Product Change Notice (PCN)

PCN Number: PCN-0450726R-01

Product(s) Affected: PJ-002AH-SMT-TR, PJ-002BH-SMT-TR

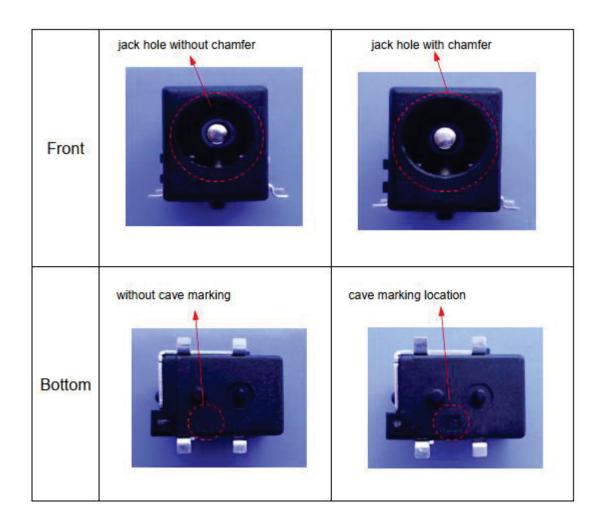
Reason(s) for Change: existing plastic housing and pin 3 molds cannot maintain efficient production.

Description of Change: to ensure quality and production efficiency, new mold development is in process. Aesthetic changes as shown below. Electrical structure and function remain unchanged.
